Docket No. 50-346

This is in response to your letter dated September 22, 1982 (Log No. 1089) concerning Secondary Water Chemistry Monitoring and Control. The attachment contains Toledo Edison's response to your letter for Davis-Besse Nuclear Power Station Unit No. 1.

SECONDARY WATER CHEMISTRY MONITORING PROGRAM
DAVIS-BESSE NUCLEAR POWER STATION UNIT NO. 1

DAVIS-BESSE NUCLEAR POWER STATION, UNIT No. 1
CHEMISTRY & HEALTH PHYSICS
ORGANIZATION CHART

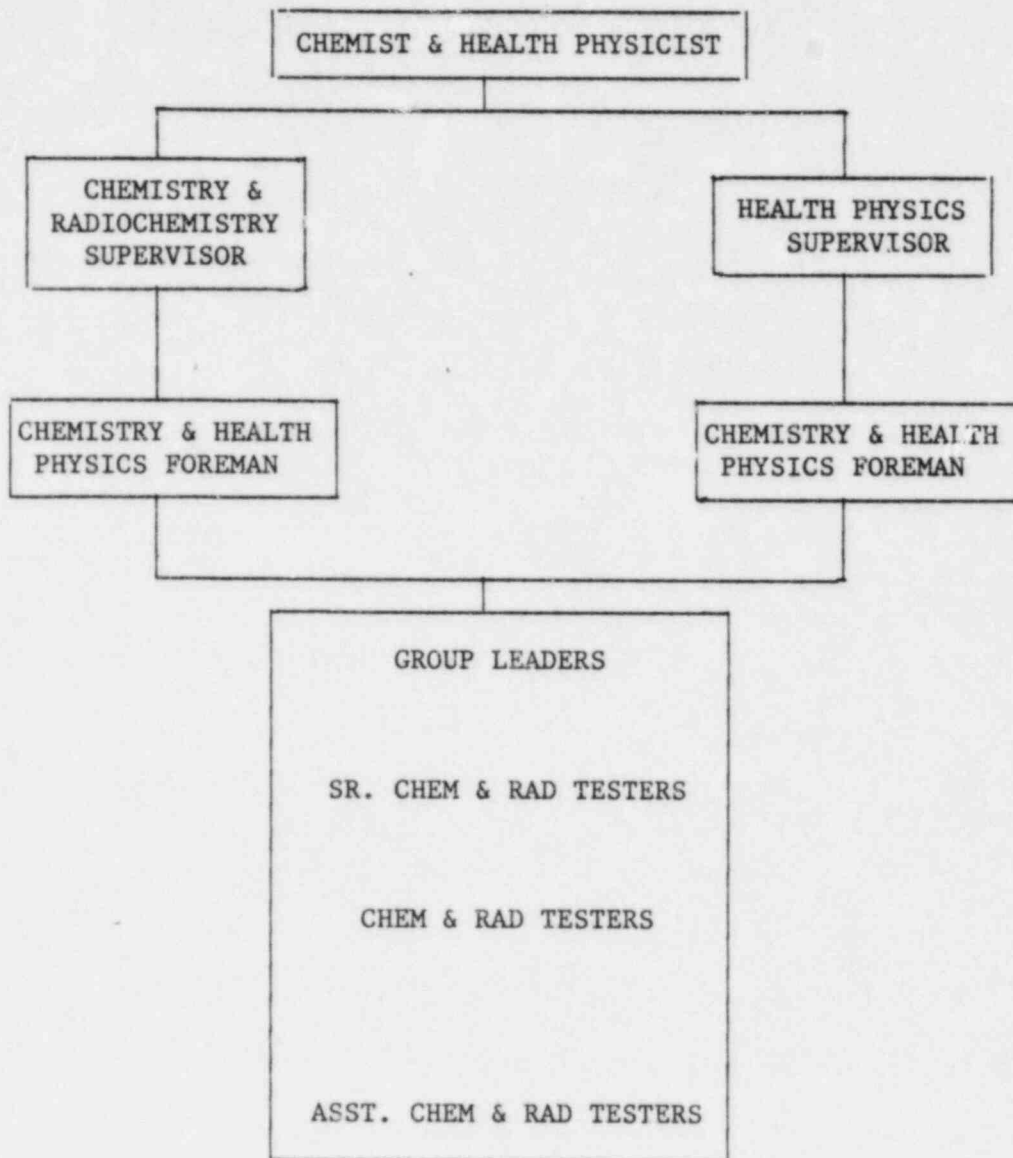
6. The procedures identifying (a) the authority responsible for the interpretation of the data and (b) the sequence and timing of administrative events required to initiate corrective action.

The attached organizational chart shows the division of responsibility within the Chemistry and Health Physics Section at Davis-Besse Nuclear Power Station Unit No. 1. The following procedures detail the administrative actions required for initiation of corrective action for off-control point chemistry conditions.
